# SIGNIFICANT CHANGES

*Introduced Since the 1995  
Master Plan Submission*

JUMBO GLACIER RESORT recently completed the most extensive environmental assessment program for any mountain resort in Western Canada. As a result of this process, a number of significant design changes have been introduced since the 1995 Draft Master Plan submission. The following changes are reflected in the current 2003 Master Plan Concept:

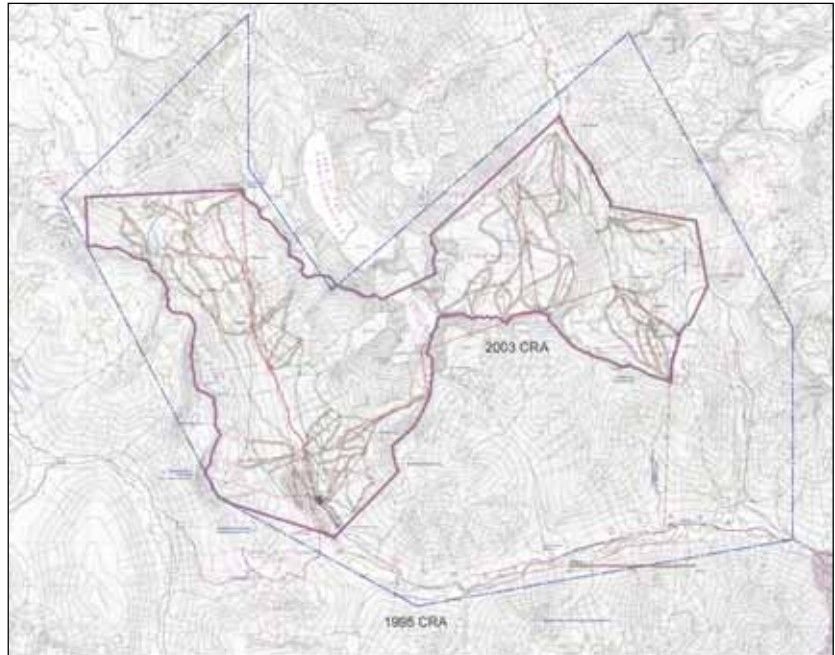
1. **REMOVAL** of a ski lift into the Horsethief Creek drainage and of any physical access into that drainage. This ensures that there will be no physical access into the Lake of the Hanging Glacier drainage from the resort.

2. **REMOVAL** of two ski lifts and ski runs at the south end of the project in order to eliminate any possibility or notion of a visual or physical impact on the current recreational use of the Jumbo Pass area.

3. **SIMPLIFICATION** and reduction of the lift system and design capacity. Comfortable Carrying Capacity is reduced to approximately half of the 1995 submission. A low utilization rate is planned and the lift system is designed with an average daily utilization rate of 2,900 people at peak periods on completion.

4. **REMOVAL** of a parking area and bus access facilities at the Mineral King Mine site.
5. **DEDICATION** to the Canadian athletes' summer training program planned by the Calgary Olympic Development Association (CODA) and others of an optional ski lift that would provide access from lower Jumbo Creek to the top of Farnham Glacier. A proposed day skier parking area connected with this lift is removed.

6. **CONTRACTION** of the resort area. All future parking and access to ski lifts are contained within a compact resort base centred on a defunct sawmill site in upper Jumbo Creek. The resort area will be contained on approximately 104 hectares. It will be the most compact ski resort in the Province.

7. **REDUCTION** of the bed base to 5,500 tourist bed-units and 750 staff bed-units.
8. **REMOVAL** of the Glacier Dome Lodge and deletion of an initial phase at the base of Glacier Dome. The first phase is moved to the sawmill site area and will become the core of the resort base.

9. **REMOVAL** of the lower Jumbo Creek area from the Controlled Recreation Area (CRA). This area has been perceived as having greater sensitivity in terms of wildlife issues.

**10. REDUCTION** of the Controlled Recreation Area (CRA) to less than half of the earlier Master Plan. The CRA has been reduced from 14,866 hectares to 5,925 hectares. The CRA will still contain the most impressive ski area in North America. It will feature a vertical drop of 1,700 metres (5,500 feet), which will be the largest in North America, all located in ideal climatic conditions for skiing. The abundance of natural snow and powder conditions in winter are
